**Re: Union Gas Limited (“Union”)
Owen Sound Replacement Project
Board File # EB-2012-0430**

This letter is to update the Ontario Energy Board with respect to a number of minor changes to the schedule and the running line of this project.

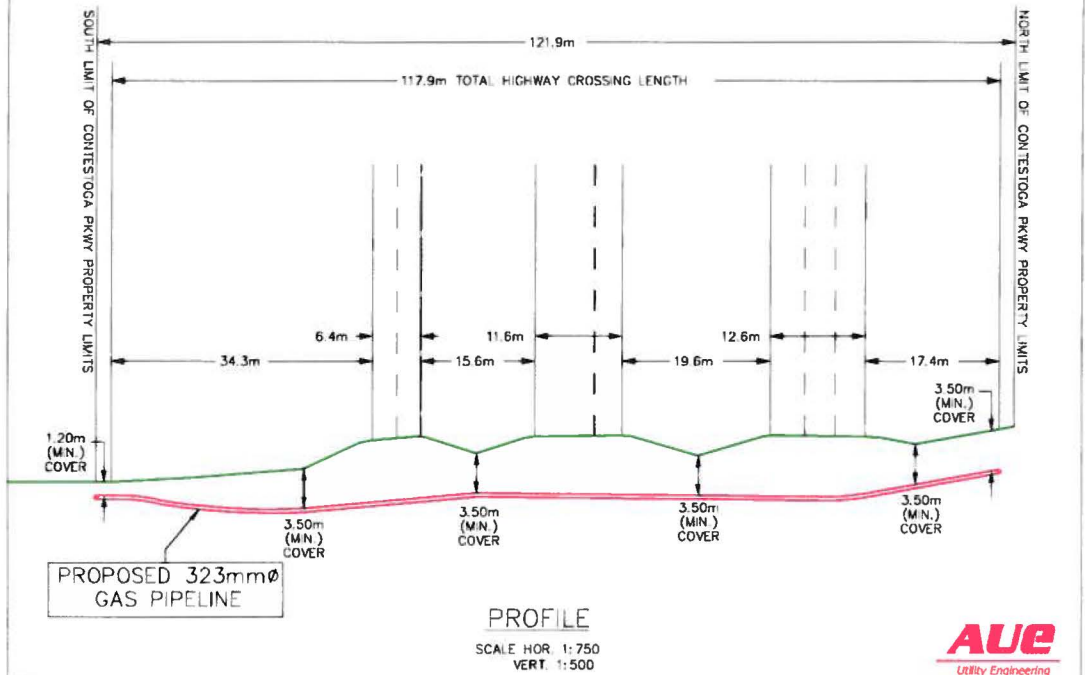
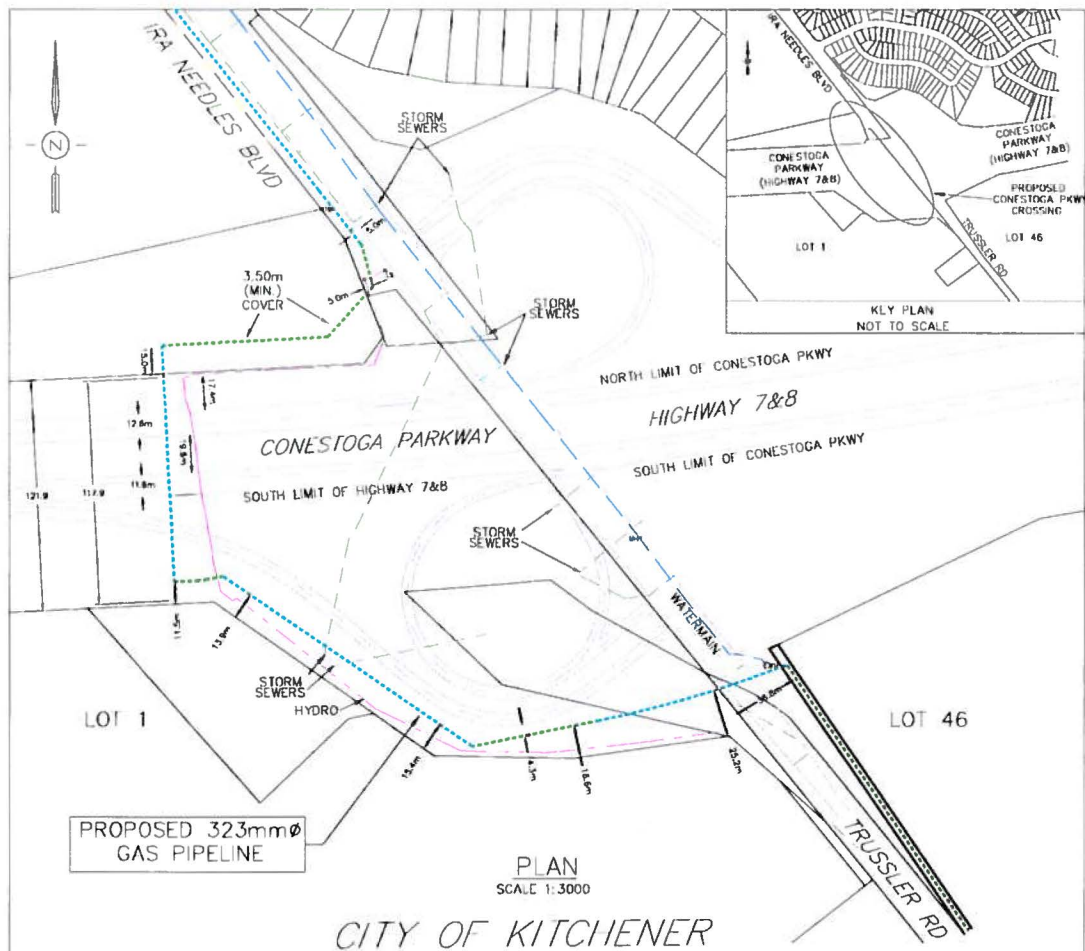
- Union's original plan for constructing across Highway 7/8 was to be within the road allowance for Trussler Road and to construct the pipeline approximately four meters from the edge of the pavement on the east side of Trussler Road. During discussions with MTO and the Region of Waterloo, Union became aware of future development plans for the interchange including future road widening at this location. Based on this proposed future development, Union designed a revised plan for this area. Union's revised plan included constructing the pipeline within existing road allowance and private easements. Union was able to obtain easements from two landowners adjacent to Trussler Road and Highway 7/8, so that the revised plan could be implemented. A map showing the revised location of the pipeline is attached.

METHOD OF INSTALLATION: HORIZONTAL DIRECTION DRILL
